## INDIANA & MICHIGAN ELECTRIC COMPANY

### DONALD C. COOK NUCLEAR PLANT

INDIANA AND MICHIGAN ELECTRIC COMPANY  
DONALD C. COOK NUCLEAR PLANT  
INSTRUCTION AND PROCEDURE CHANGE SHEET

TITLE: INITIAL CORE DAMAGE ASSESSMENT

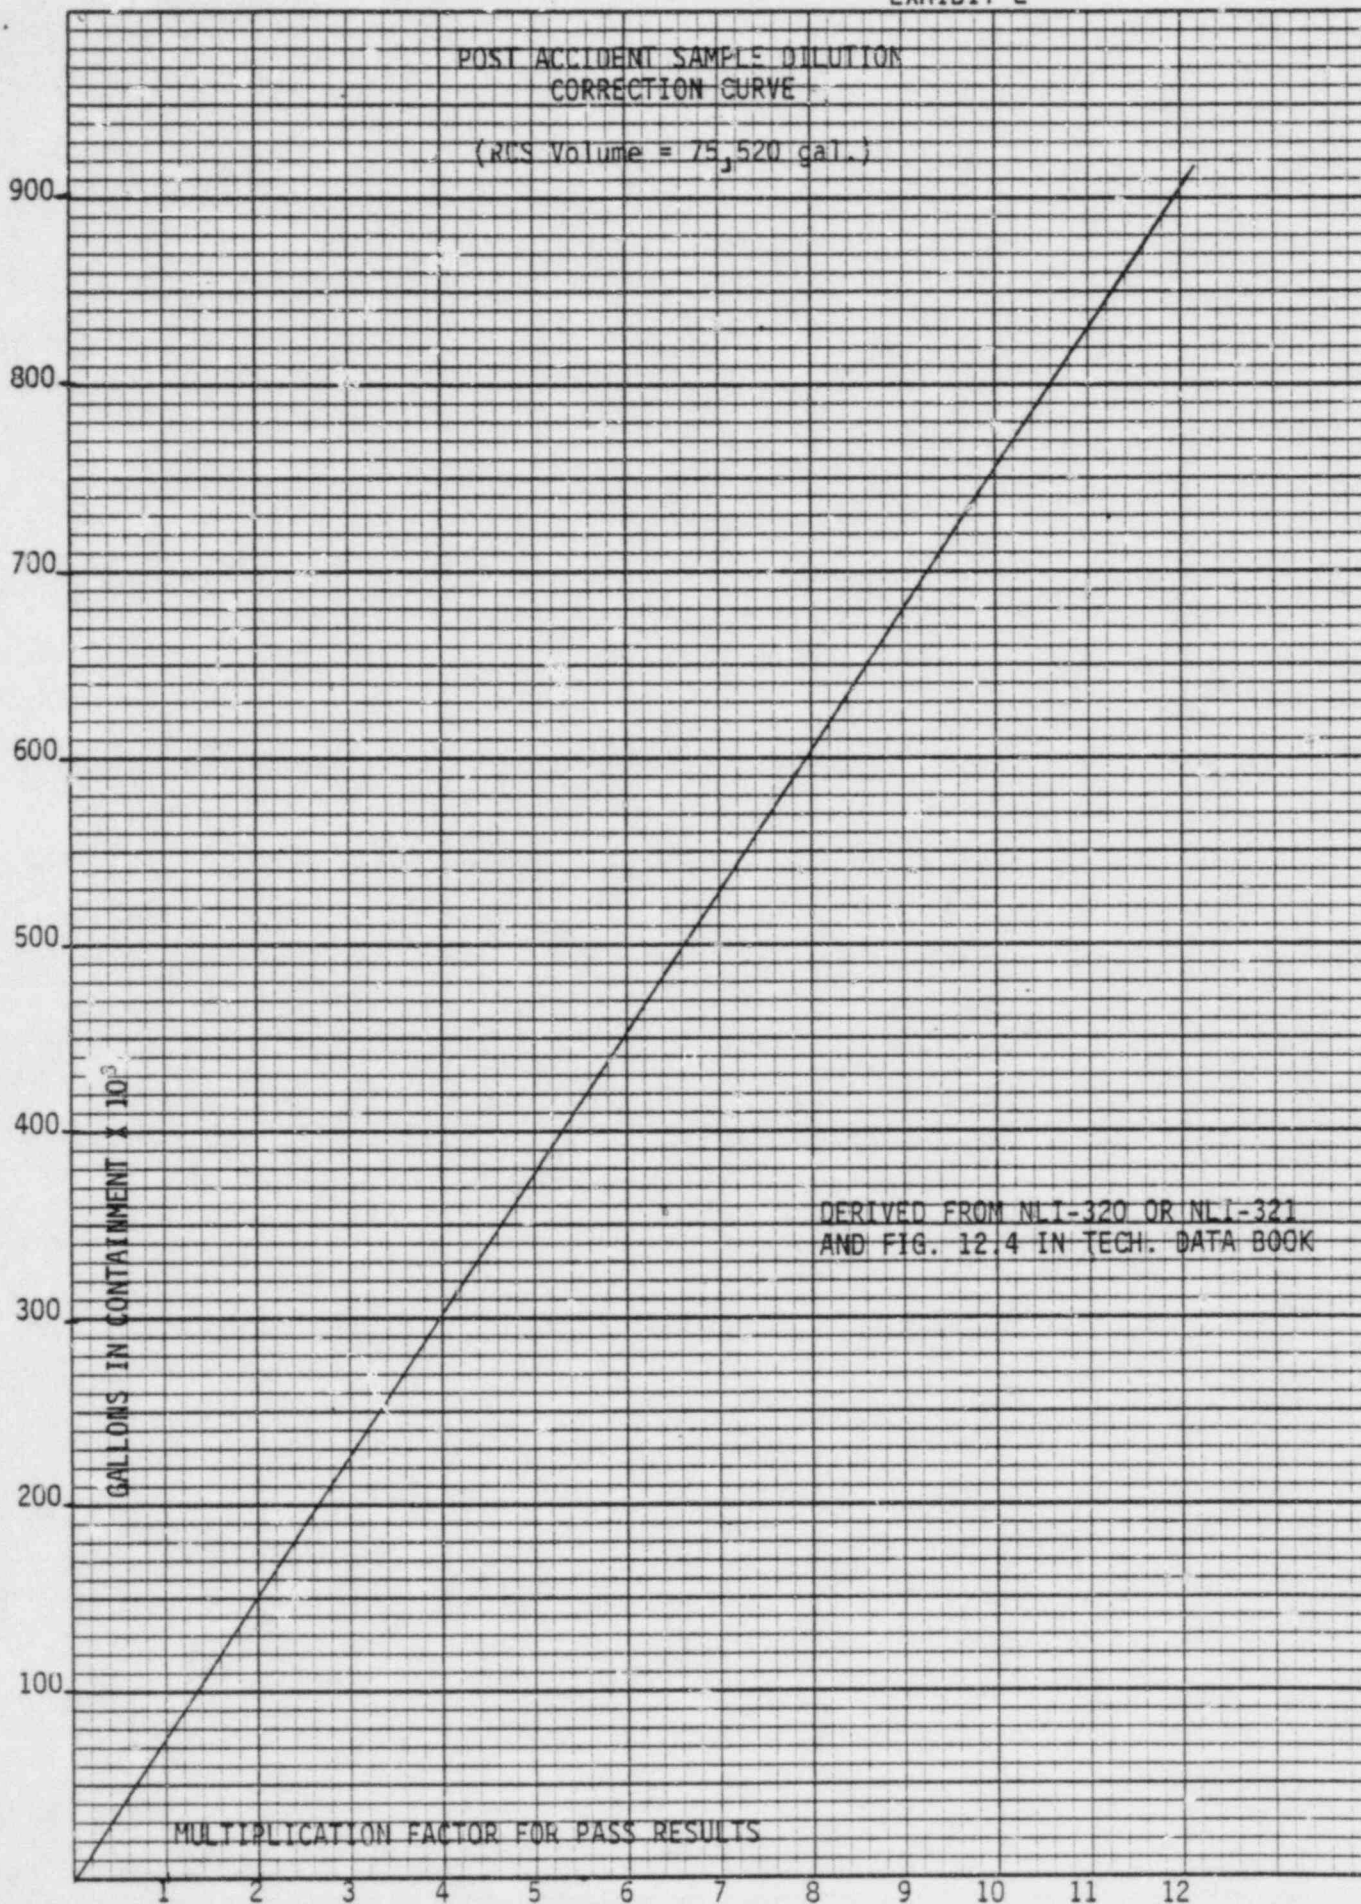
Correction of containment sump samples for dilutions during post accident conditions.

Samples obtained via the post accident sampling panel are automatically diluted by a factor of 1000. In case further sample dilution is required, the measured radionuclide concentrations should be multiplied by a second dilution factor ( $DF_1$ ).

If the reactor coolant system is incapable of maintaining pressure during a LOCA, use of the PASS for coolant system and/or RHR samples may not be possible. In such an event, samples of the lower containment

volume may be collected via the PASS, and sample activity results must be corrected for dilution by use of form 2081.EPP.029 Exhibit E.

$$DF_1 = \left( \frac{w}{w^1} + 1 \right)$$

where:  $w$  = total weight of diluent material (weight of stable material), i.e. distilled water.

$w^1$  = total weight of undiluted material (weight of radioactive material).
